**RE: Cunningham Hill Pit Slope Stability Analysis Revision 01, Cunningham Hill Mine,
Permit No. SF200RE**

In response to the New Mexico Mining and Minerals Division's (MMD) August 28, 2023, Comments on the Pit Slope Stability Analysis Report letter, LAC Minerals (USA) LLC hereby provides the enclosed revised Memorandum prepared by Call & Nicholas, Inc.

Subject: Cunningham Hill Pit Slope Stability Analysis – Revision 01

SCALE 1"=200' **FIGURE 1**

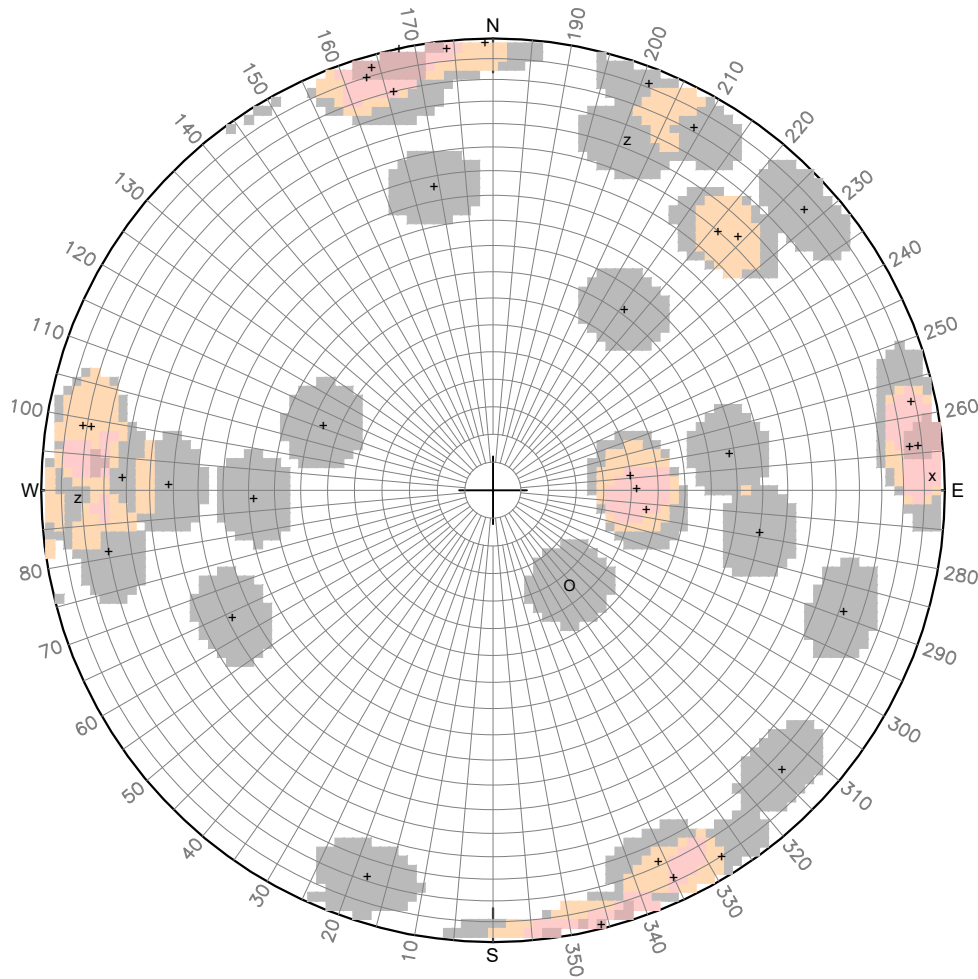
As requested by MMD, the revisions add a description of Volcanic Breccia joint sets in Section 4.2 and add Table 1 with descriptions of geologic acronyms used in Figure 1.

Table 1. CHMRP Pit Geology Descriptions for Figure 1
